**STAFF REPORT**

SUBJECT: H-2022-0094  
Chipotle – CUP

LOCATION: 1737 S. Meridian Rd., in the NE 1/4 of Section 24, T.3N., R.1W. (Parcel #R5652350045)

Conditional Use Permit (CUP) for a drive-through establishment within 300-feet of another drive-through establishment, a residential zoning district and existing residences on 1.38 acres of land in the C-G zoning district.

## A. Proposed Site Plan (dated: 8/24/2022) - Revised

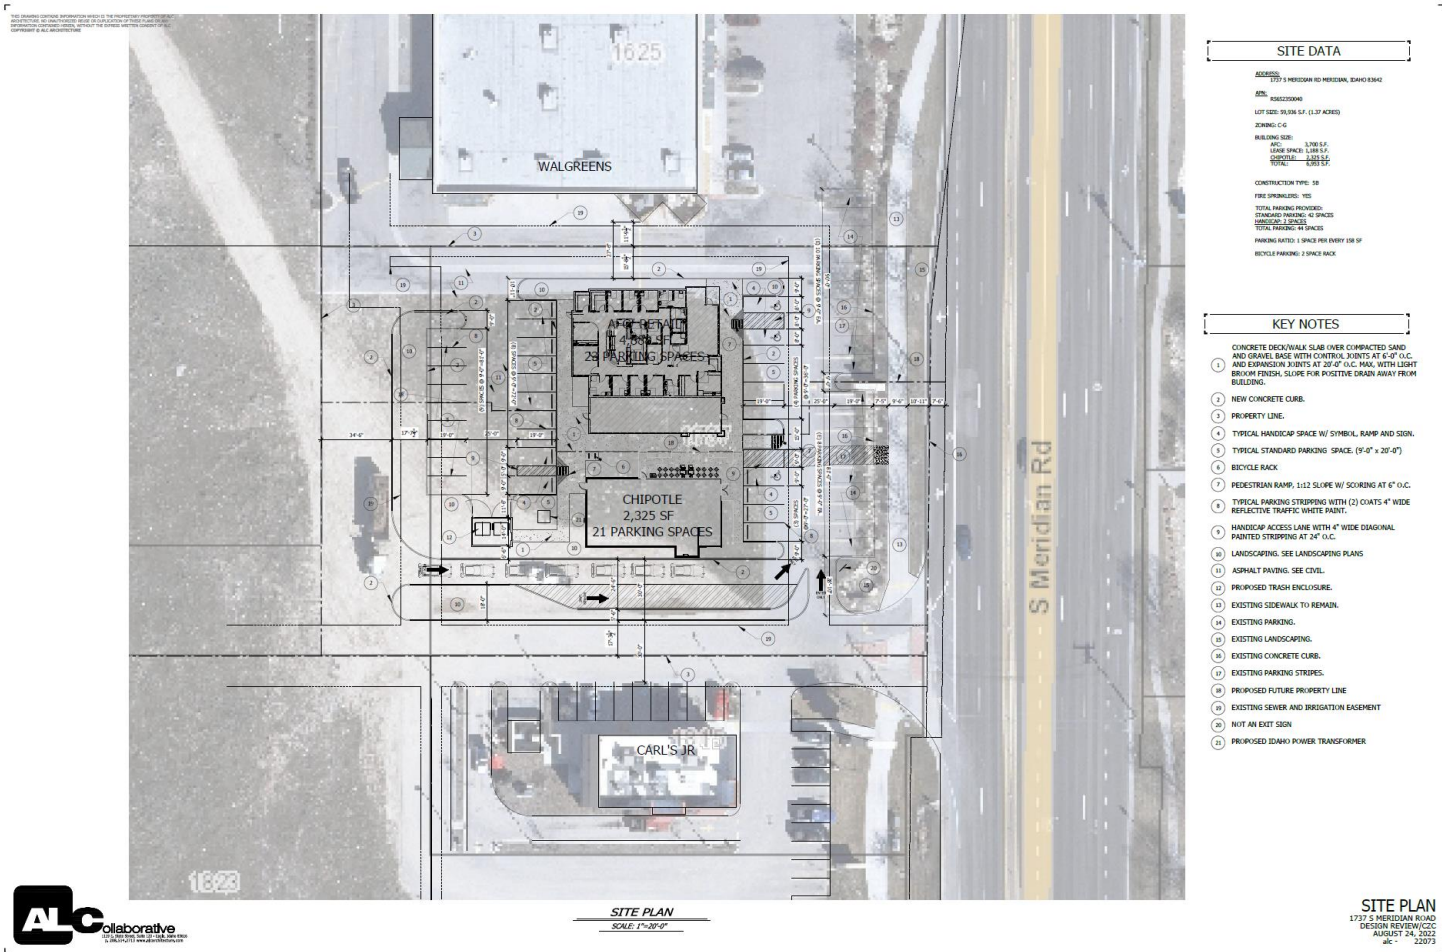
**Drive-Through Establishment:** The proposed drive-through establishment is subject to the specific use standards listed in UDC [11-4-3-11](#), Drive-Through Establishment. All establishments providing drive-through service are required to identify the stacking lane, menu and speaker location (if applicable), and window location on the site plan. *The stacking lane and window location is depicted on the site plan; a menu board and speaker are not proposed.*

*The site plan depicts queuing for 7-8 vehicles, which should be sufficient for the proposed use as a pick-up only drive-through.*

*The stacking lane is a separate lane from the circulation lanes needed for access and parking and allows for 7-8 vehicles to stack.*

*The length of the drive-through is approximately 145 feet from the point of entry to the drive-through window; therefore, an escape lane is required as depicted on the site plan.*

*The drive-through is located on the south side of the building and is visible from SH-69/S. Meridian Rd. and from the driveway into the development adjacent to the southern boundary of the site.*

**Access:** Access is proposed from the existing east/west driveway via SH-69/S. Meridian Rd. that runs along the southern boundary of this site and provides access to the lots in Medina Subdivision. A variance ([VAR-05-027](#)) was approved by City Council in 2005 for this access. **This driveway is required to be extended to the property to the west (Parcel #R5652350065) as a provision of the variance approval.**

**A right-in only access is proposed to the site from the main driveway from SH-69/S. Meridian Rd. Traffic will exit the site to the north to avoid traffic conflicts at the southeast corner of the site with vehicles turning into the development from the highway.**

**Landscaping:** Street buffer landscaping was installed within the street buffer along SH-69/S. Meridian Rd., an entryway corridor, with the Medina subdivision improvements. *Note: The aerial view of the property depicted on the site plan that shows parking stalls encroaching within the street buffer is not accurate; the buffer is will remain the same and is not proposed to be modified.*

Parking lot landscaping is required to be provided in accord with the standards listed in UDC [11-3B-8C](#). **A 5-foot wide perimeter buffer is required along the west boundary of the site, landscaped per the standards listed in UDC [11-3B-8C.1b](#). The plans submitted with the Certificate of Zoning Compliance application should be revised to reflect compliance with this standard. A perimeter buffer is not required along the north or south boundaries of the site as those are shared driveways with the adjacent properties.**

**Sidewalks:** A 10-foot wide sidewalk/multi-use pathway exists within the street buffer along SH-69/S. Meridian Rd. in accord with the Pathways Master Plan and UDC 11-3H-4C.4. **A pedestrian walkway is proposed from the perimeter sidewalk/pathway along SH-69/S. Meridian Rd. to the main building entrance in accord with UDC [11-3A-19B.4](#). Where the pathway crosses vehicular driving surfaces, it's required to be distinguished through the use of pavers, colored or scored concrete, or bricks as set forth in UDC 11-3A-19B.4b. The site/landscape plan submitted with the Certificate of Zoning Compliance application should reflect compliance with this standard.**

**Easements:** There are existing easements on this lot as shown on the Medina subdivision plat and ROS #13573. **These easements should be depicted and labeled on the plans submitted with the Certificate of Zoning Compliance application. The proposed structure shall not encroach within these easements, except as allowed in the UDC.**

3. The site plan and landscape plan submitted with the Certificate of Zoning Compliance application shall be revised as follows:
  - a. Depict and label all easements that exist on the subject lot per the recorded plat (Medina Subdivision) and Record of Survey (#13573). Any encroachments within existing easements should be permitted through the easement holder or as allowed by the UDC.

- b. Depict a minimum 5-foot wide perimeter buffer along the west boundary of the site, landscaped per the standards listed in UDC [11-3B-8C](#). *A perimeter buffer is not required along the north or south boundaries of the site as those are shared driveways with the adjacent properties.*

- c. Extend the main east/west driveway from SH-69/S. Meridian Rd. along the southern boundary of the site to the property to the west (Parcel #R5652350065) as required by City Council with approval of the variance ([VAR-05-027](#)).

- d. The walkway from the perimeter sidewalk/pathway along SH-69/S. Meridian Rd. to the main building entrance shall be distinguished from the vehicular driving surface through the use of pavers, colored or scored concrete, or bricks as set forth in UDC [11-3A-19B.4b](#).
